**DEVELOPMENT REVIEW COMMISSION
STAFF REPORT**

CASE NO.: 20-31000010 PLAT SHEET: I-52

REQUEST: Approval of a Site Plan modification to construct a 116,000 square-foot building addition to an existing light manufacturing facility in the EC-1 zoning district. The applicant is requesting a variance to parking.

HALKEY ROBERTS EXPANSION
 SITE PLAN

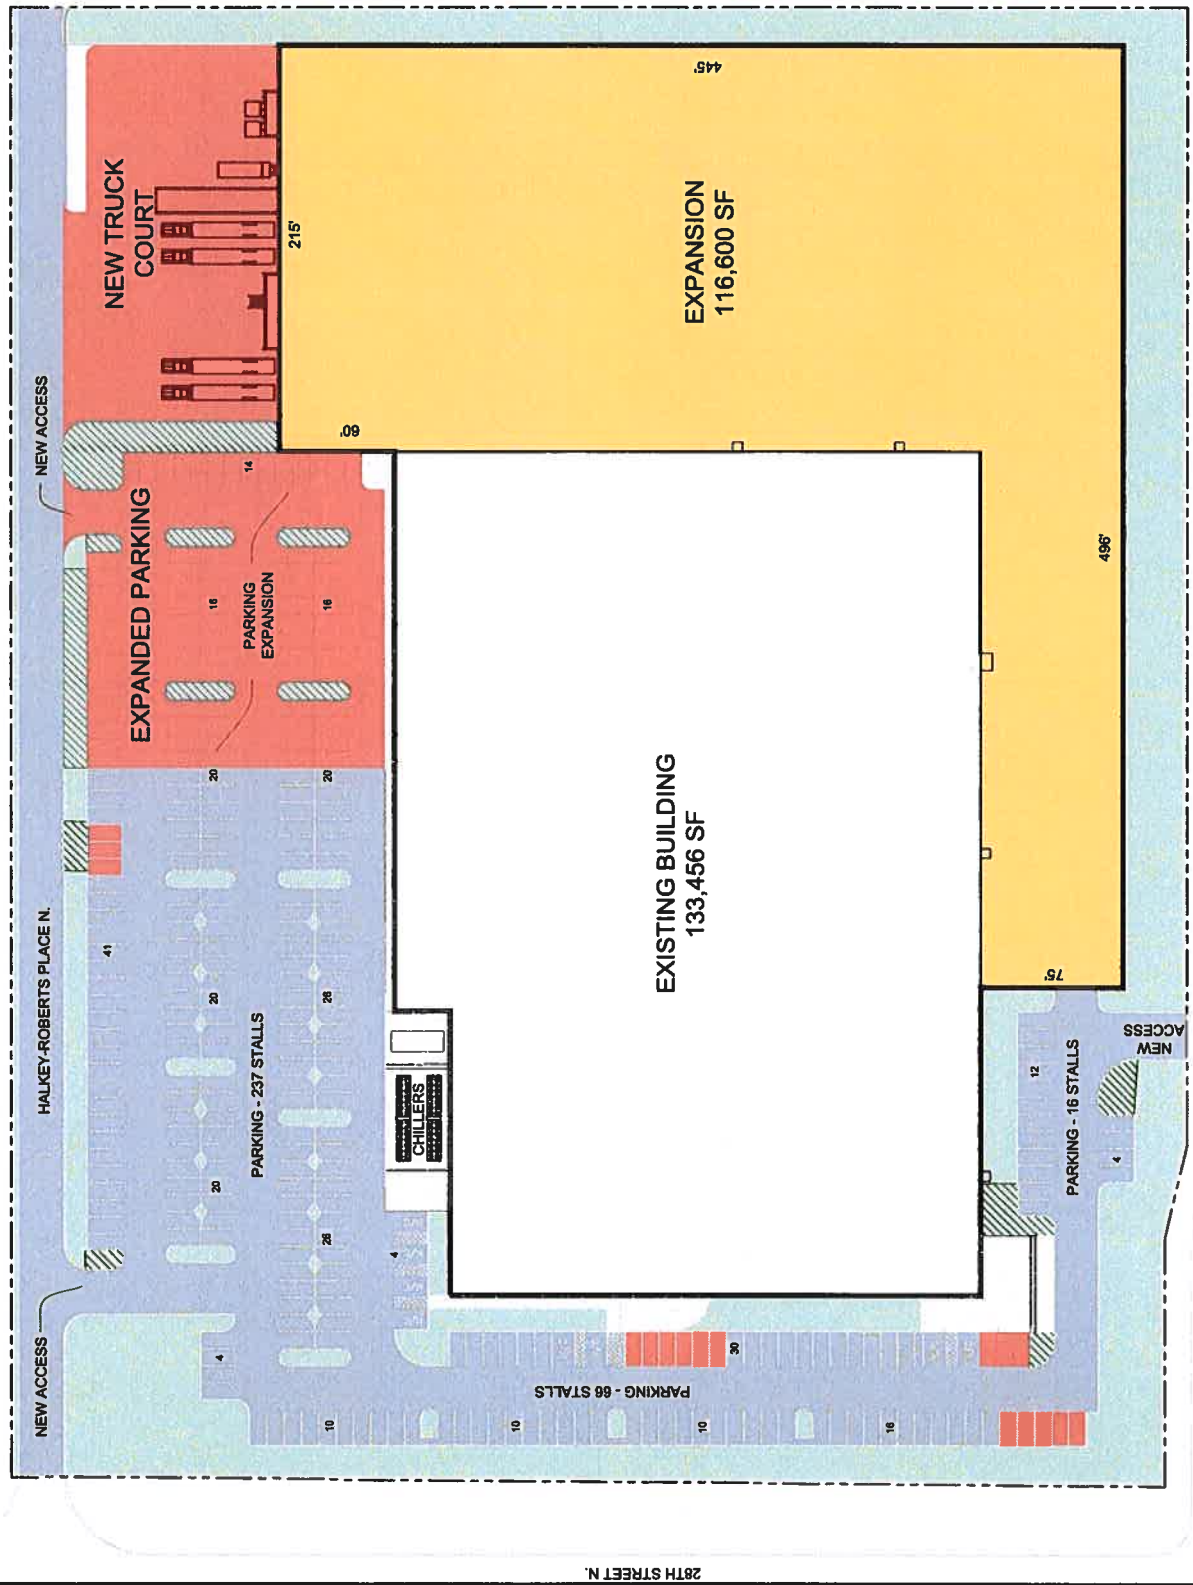
A manufacturing facility in the Employment Center-1 (EC-1) zoning district requires one parking space per 500 square feet. The applicant is proposing 319 parking spaces and is required 546 parking spaces. The applicant provided a breakdown of the existing employees per shift, with 217 employees being the highest number. At the most, 304 employees may be on-site at once during a shift change. Over the years, the applicant states that parking utilization has been between 75-80%. There are currently 259 parking spaces on-site, therefore 207 of those spaces are utilized. The applicant projects an increase in the number of employees from 217 to 252 during the shift with the most staff. The majority of the space in the existing and new facility will be devoted to equipment. The applicant is also proposing to stagger shifts to ensure that the overlap of employees on-site does not create a parking problem.

The application was routed to the City’s Transportation Department for review. They found that the City Code requirements for required parking exceed what is required by ITE studies. The ITE studies found that parking for a light industrial use would require 146 spaces and a building of this size located in an industrial park would require 287 spaces. They also reviewed historic aerials and found that maximum utilization of the existing parking lot never exceeded 80%.

6. The site plan shall be modified as necessary to comply with the comments in the Transportation Department's email dated, 2020.
7. The site plan shall be modified as necessary to comply with the comments in the Water Resources Department's email dated, 2020.

8. The site plan shall be modified as necessary to comply with the comments in the Engineering Department's Memorandum dated 2020.
9. This Special Exception/Site Plan approval shall be valid through September 22, 2023. Substantial construction shall commence prior to this expiration date, unless an extension has been approved by the POD. A request for extension must be filed in writing prior to the expiration date.

1. Variance to parking; and
2. Site Plan Modification, subject to the Special Conditions of Approval.
